Title: Advisory Committee on Reactor Safeguards
 ABWR Subcommittee: Open Session

Date: Tuesday, October 4, 2011

South Texas Project Units 3 & 4 ACRS ABWR Subcommittee Presentation

Action Item # 98 - Validation of Method Applicability *(continued)*

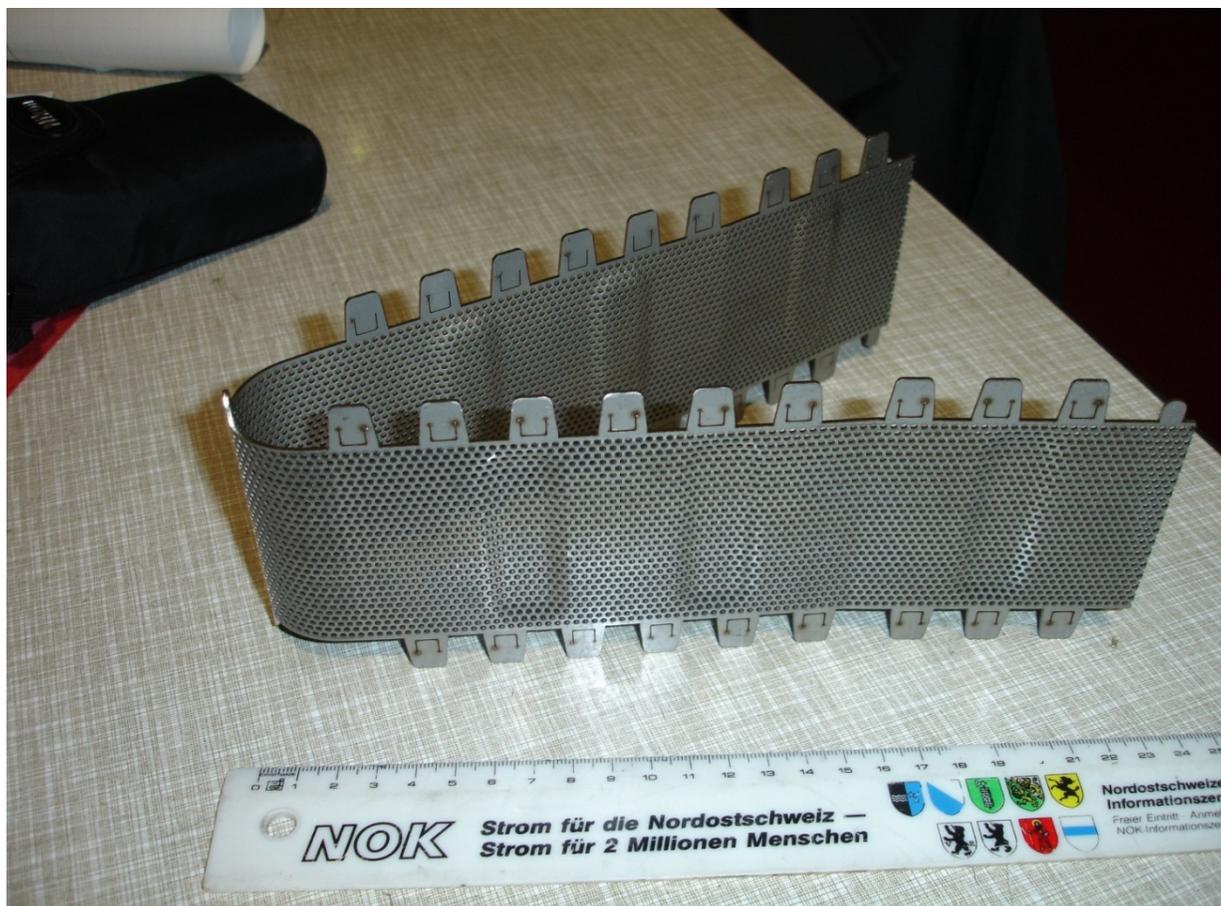
3 CONSULTANT WALLIS: I understand. What is
4 yielding? Is it yielding and bending or what? Which
5 way is it yielding? You have to show me the test,
6 because 1 millimeter doesn't mean anything unless I
7 know 1 millimeter of what.

2 CHAIR ABDEL-KHALIK: Well, if you show us
3 whether -- the sample how it was tested and whether it
4 is bending, you know, we will be able to figure that
5 out. I just --

16 MEMBER SHACK: When I saw the pictures of
17 this, I always assumed those pockets were perforated
18 on all sides. You are telling me that it is really
19 two solid plates and a porous U? Which comes back to
20 Said's question of whether this is really totally
21 representative of the geometry.

19 CONSULTANT WALLIS: But it's also a
20 question of how you -- what you did with these tabs.
21 I mean, this thing is fixed to the other plate with
22 these tabs.

20 MEMBER SHACK: Well, let me try another
21 argument here that what you have really demonstrated
22 with this test is that you can undergo a considerable
23 amount of plastic deformation in this sheet and not
24 tear locally.

2 MS. SCHLASEMAN: But for the test, they
3 didn't use the side plates. That's correct, they are
4 perforated on the sides. But in this test fixture,
5 they did not do it that way.

12 MS. SCHLASEMAN: But I think considering
13 how the -- if the plates were -- on the side had been
14 the perforated sheets, and, obviously, they would be
15 weaker, I mean, surely they would be weaker, but
16 because of the way you are loading it, you are loading
17 it like a membrane. And so I'm still thinking that
18 the load -- you know, the question about the holes
19 tearing open and the pockets -- I mean, that was your
20 original question about whether or not the pockets
21 would tear open, and I'm not seeing how it would
22 necessarily tear open differently.

- RJ-ABWR limiting load combination pressure ~0.5 bar (7.25 psi)
- Tested 6 cycles (*see figure, next slide*) starting with 1 bar up to 2.25 bar
 - At 1 bar: deformation within elastic regime
 - At 2.25 bar: no damage; permanent deformation ~1.0 mm

Figure 19E.2-6a: UO₂ Temperature

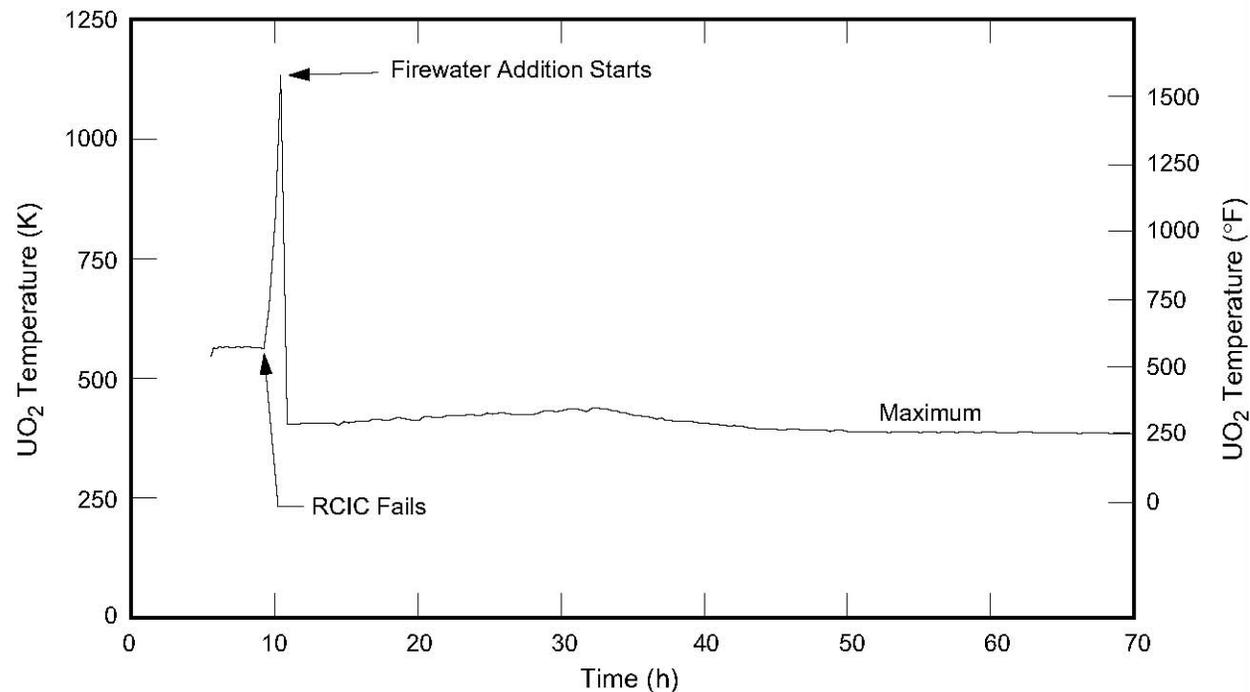
9 CONSULTANT WALLIS: So it looks as if it
10 makes a difference of -- you know, if you move this
11 thing by 10 minutes one way or the other, you can
12 change that spike quite a bit.

12 MR. THOMAS: On the next sheet, this just
13 shows the plot of the fuel temperature throughout this
14 transient. As you can see, when RCIC injection
15 ceases, you get a pretty significant spike in fuel
16 temperature. The peak is 1610 degrees from the
17 analysis, which is below the -- it's the level at
18 which we anticipate fuel damage.

Figure 19E.2-6a: Drywell Pressure

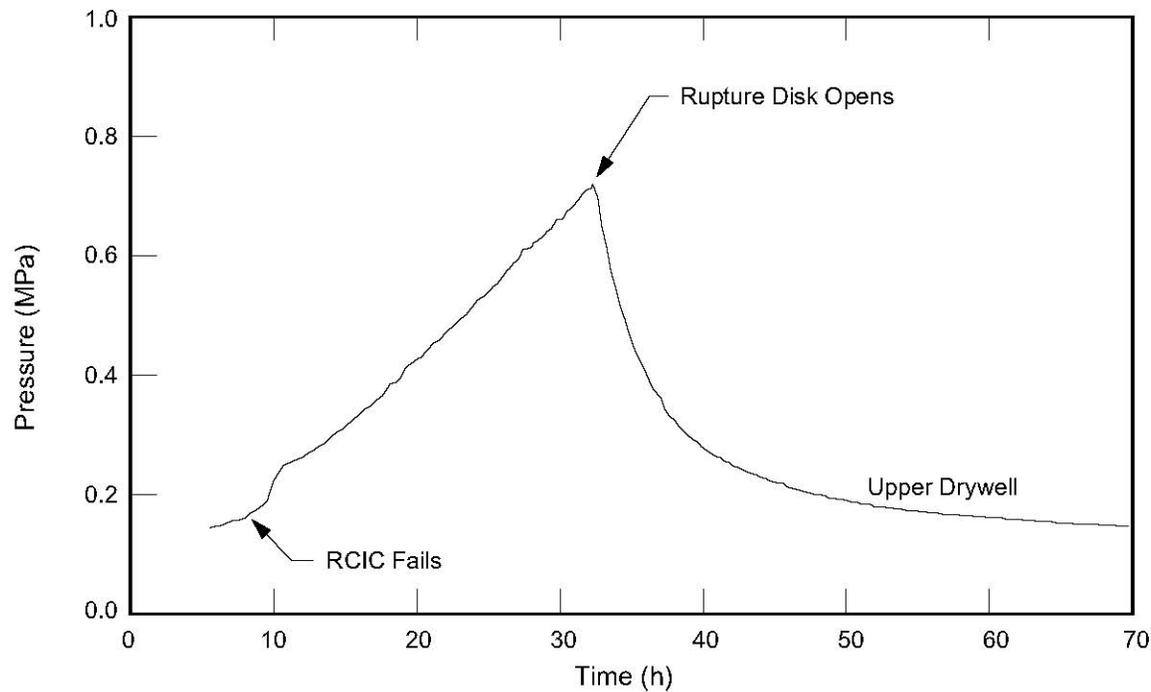
8 CONSULTANT WALLIS: So this just -- excuse
9 me. This Slide 7 is responding to my question, isn't
10 it? This is over-raced, but we getting the firewater
11 going and the water level falling in the vessel?

2 Likewise on the next sheet, if you look at
3 containment pressure, when RCIC fails, of course,
4 containment pressure starts to increase pretty
5 dramatically until the rupture disc opens again at 90
6 pounds. It decreases rapidly and again approaches
7 equilibrium for a considerable period of time.
